Access Compliance Report

Public Rights-of-Way

(Curb Ramps)

Intersection ID: 49927	Main Street: ASHBOURNE_HALL_RD	Cross Street: CAMPBELL_HALL_CT	Location: SE
ADA ID: 497A29ABB3FD	Ramp Type: Perp	Initial Pass/Fail: Fail	Overall Compliance: No
Severity Score: 13.75			
Codes/Mitigation Info/Possible Solution		Field Measurements/Component Compliance

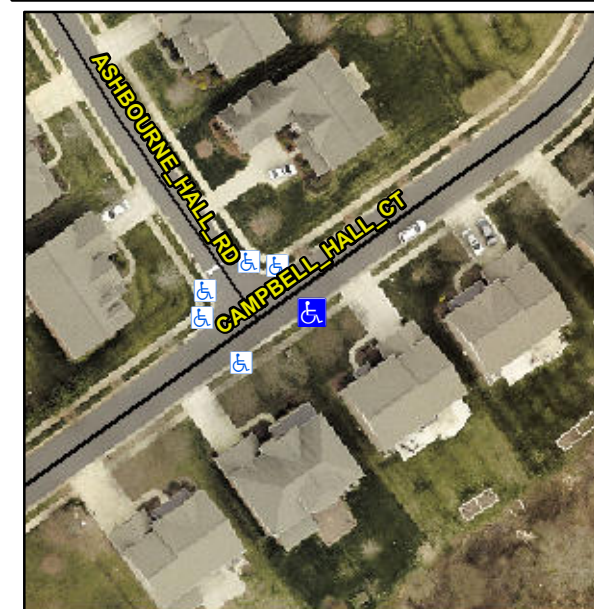
Not Found, R304.2.2

Compliance	Description	Data	Compliance	Description	Data
N/A	Ramp Length (in)	48.0	No	Ramp Slope (%)	8.7
Yes	Ramp Width (in)	48.0	Yes	Ramp XSlope (%)	2.5
N/A	Flare Type LT	N/A	N/A	Flare Type RT	N/A
N/A	Flare Slope LT (%)	N/A	N/A	Flare Slope RT (%)	N/A
N/A	Flare Traversable LT?	N/A	N/A	Flare Traversable RT?	N/A
N/A	Landing Length (in)	N/A	N/A	DWS Provided?	N/A
N/A	Landing Width (in)	N/A	N/A	DWS Contrast?	N/A
N/A	Landing Slope (%)	N/A	N/A	DWS Length (in)	N/A
N/A	Landing X Slope (%)	N/A	N/A	DWS Full Width?	N/A
N/A	Landing Curb? (Y/N)	N/A	N/A	DWS Offset (in)	N/A
N/A	Shared Landing?	N/A			
N/A	Gutter Ponding?	N/A	N/A	Gutter Slope (%)	N/A
N/A	Gutter Lip Ht (in)	N/A	N/A	Gutter X Slope (%)	N/A
N/A	Painted X Walk1?	No	N/A	Painted X Walk2?	N/A
	X Walk 1 Direction	To NW		X Walk 2 Direction	N/A
N/A	X Walk 1 Width (in)	N/A	N/A	X Walk 2 Width (in)	N/A
	X Walk 1 Slope (%)	1.0		X Walk 2 Slope (%)	N/A
	X Walk 1 X Slope (%)	3.2		X Walk 2 X Slope (%)	N/A

Remove & Replace Entire Ramp.
